ATLANTA REGIONAL COMMISSION

REGIONAL REVIEW NOTIFICATION

ARC REVIEW CODE: R1804041

Name of Proposal: 760 Ralph McGill (DRI 2801)

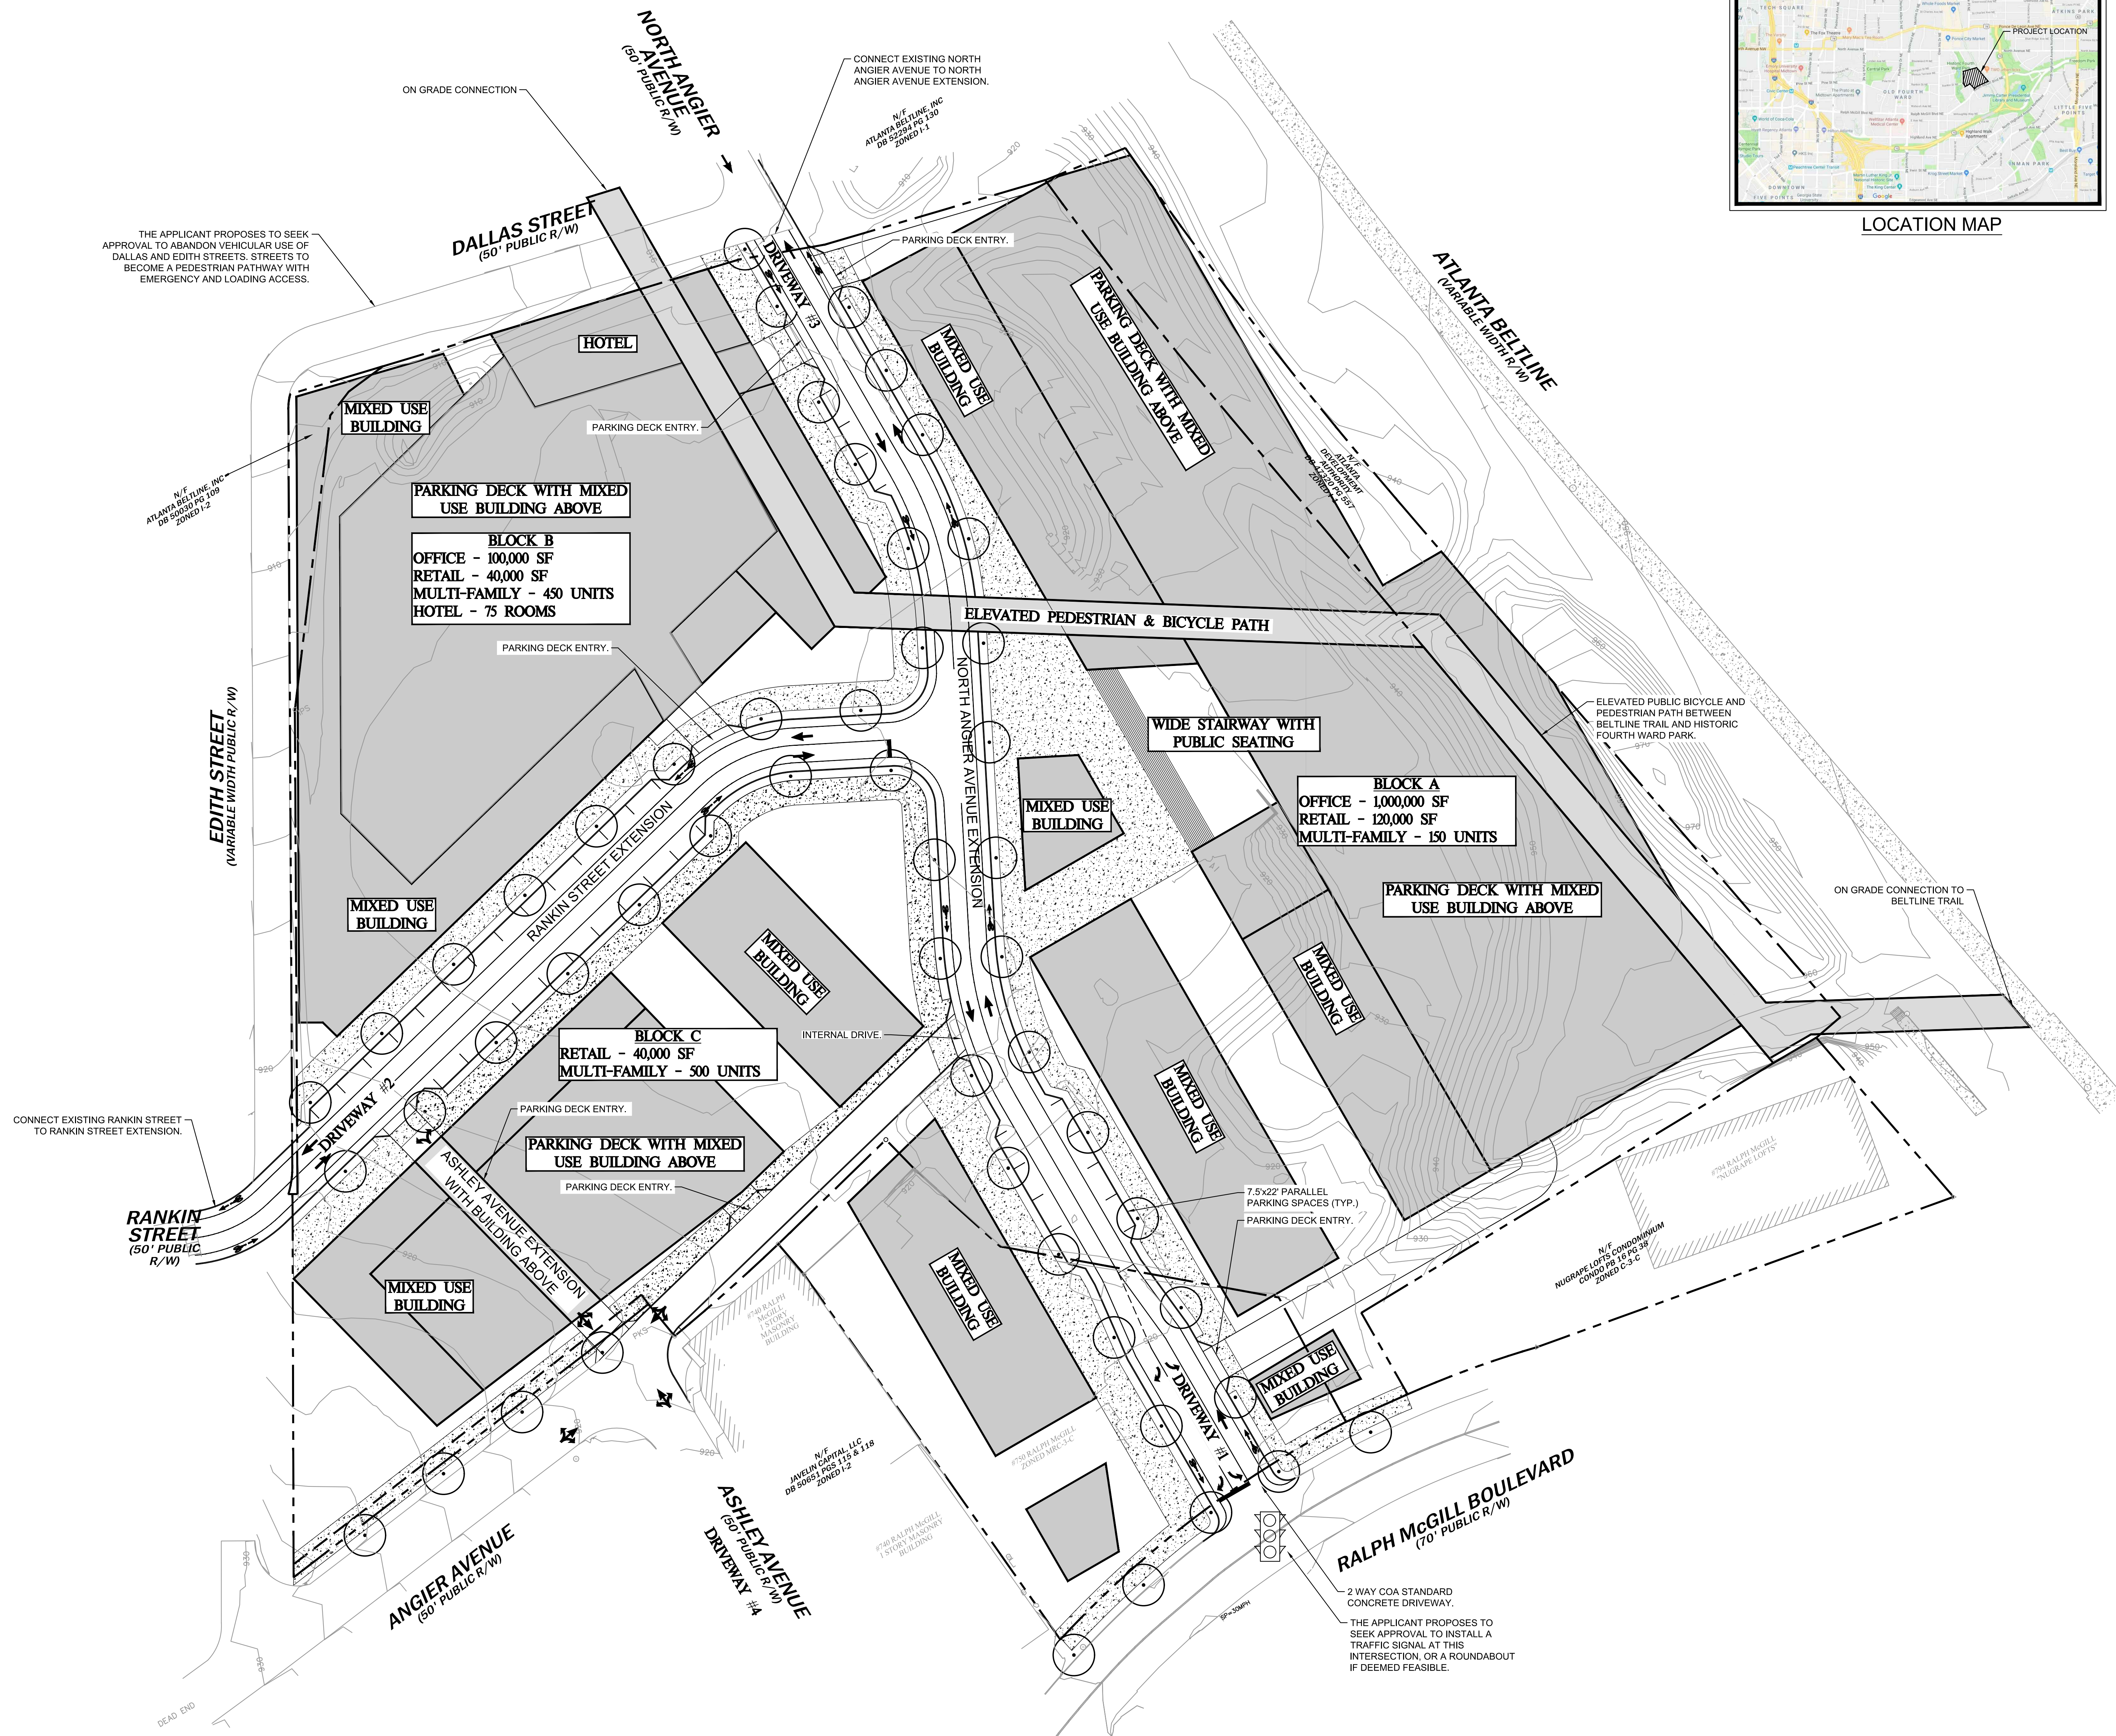
The USGS coverage for the project area shows no streams on or near the property. No streams or other waters of the State are shown on the submitted site plan and no evidence of streams or other waters is visible in available aerial photo coverage. Any unmapped streams identified on the property may be subject to the City of Atlanta's stream buffer ordinance. Any unmapped State waters identified on the property will be subject to the State 25-foot Sediment and Erosion Control buffer.

The development proposes access by four existing driveways including one full movement driveway on Ralph McGill Blvd and one each at Rankin Street, North Angier Avenue and Ashley Avenue.

Proposed driveways connecting to local roads provide access to adjacent developments.

The project proposes pedestrian facilities throughout the development. No bicycle facilities are proposed internally.

The development provides direct connectivity to the Beltline Trail and adjacent uses through existing and proposed pedestrian and bicycling facilities.
